CERTIFICATE OF APPROPRIATENESS

Property: 1913 B Crockett St, Lot 11A, Block 314, Shearn Addition Subdivision. The property is a vacant interior lot, subdivided into two lots, Lot A that measures 2,534 square feet (51' x 50'-4") and Lot B that measures 1,608 square feet (37'-8" x 42'-8").

Proposal: New Construction – Residence/Garage

PUBLIC COMMENT– Evan and Laura Michaelides

NORTH ELEVATION – FRONT FACING CROCKETT STREET

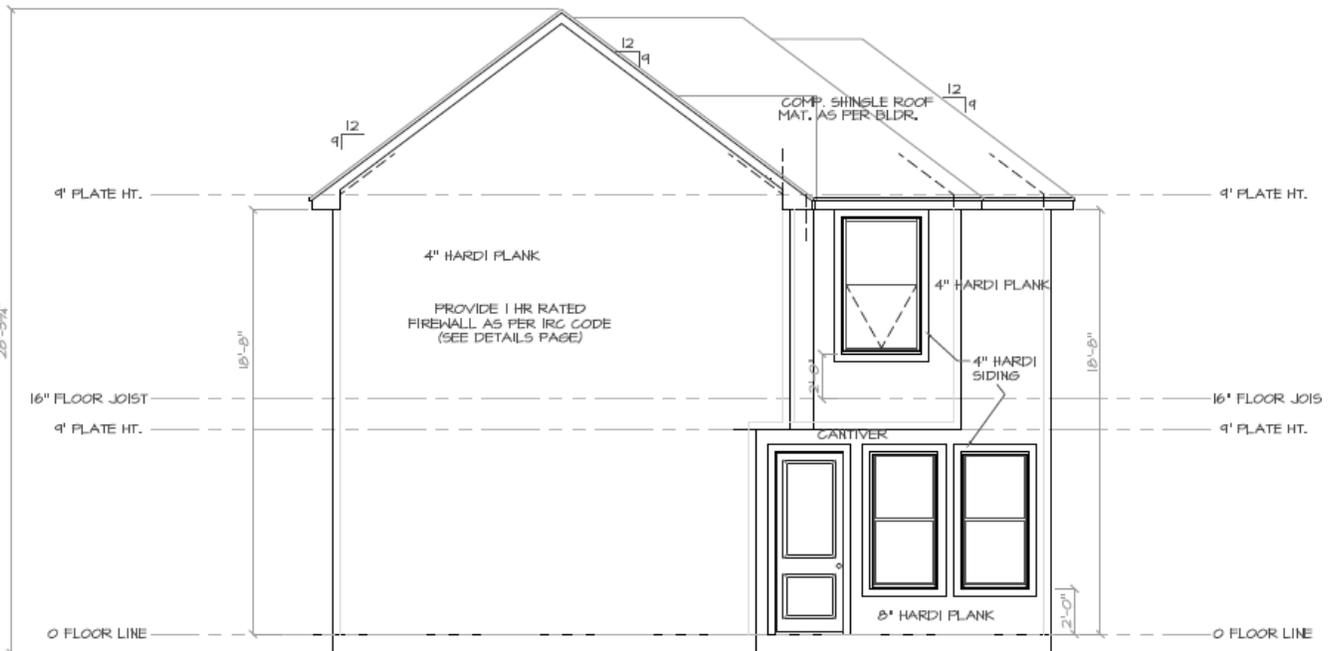
- 3.1. 8" hardie plank has been specified throughout. This material is cheap-looking and not in keeping with the historic structures in the District. 4" plank should be used instead. Additionally, the texture of the planks to be used is not noted; flat-texture planks should be used.
- 3.2. Glass block has been specified in all of the designs. This material does not seem appropriate for a historic district.
- 3.3. Many of the windows in the designs are large, single-pane fixed windows. This type of window does not seem appropriate to this historic district. 1-over-1 and 2-over-2 double-hung windows are the norm in this district.

- 4.1. On a number of the sides of the proposed structures, there are no windows at all. This is out of character for the contributing structures in the District.
- 4.2. Many of the rooflines are excessively complicated and thus not compatible with the contributing structures in the District.

SITE PLAN

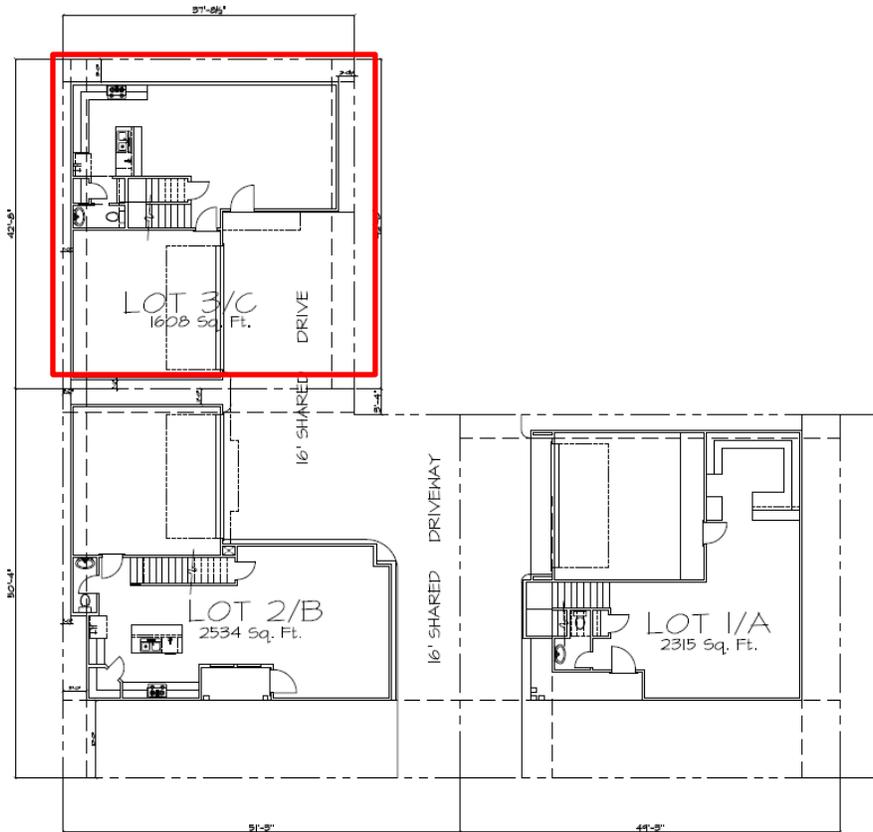
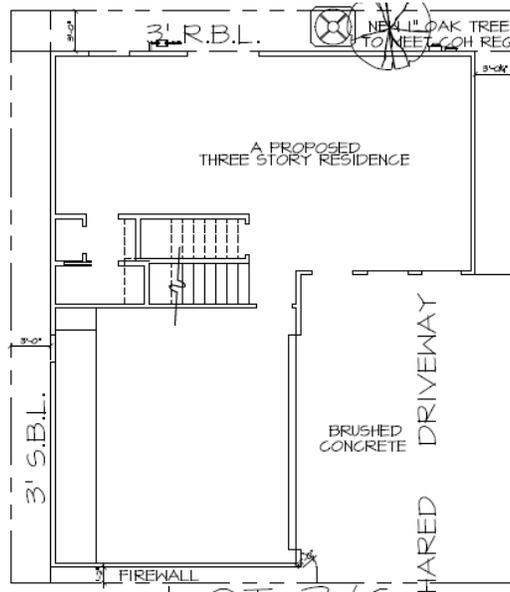
- 1.1. A site plan is required for a COA application. Each of these applications includes a drawing labeled "Site Plan". However, these purported site plans do not indicate the orientation of the proposed buildings to the surrounding streets or to each other. In addition, the elevations are listed as "left", "right", etc. instead of the usual "north", "south" etc. All this is contrary to industry standards, and makes the site plans are very difficult to decipher. This needs to be addressed in order to make the proposed plans more readily understandable.

- 1.2. Given the close proximity and interrelationships of the proposed buildings with one another, a site plan should be provided that covers all the buildings in the project so that what is being proposed can be understood.

- 1.4. The historic/contributing structure at 1907 Crockett is known to encroach on its neighbor to the west (1913 Crockett). This encroachment is not shown on the site plan. This omission is significant, since it affects the actual distance that will separate the new structure at 1913 from the existing one at 1907.

- 1.5. A 10' setback from the street is noted. This is out of character for the District, where setbacks of 15 feet or more are prevalent on contributing structures. Is this permissible?
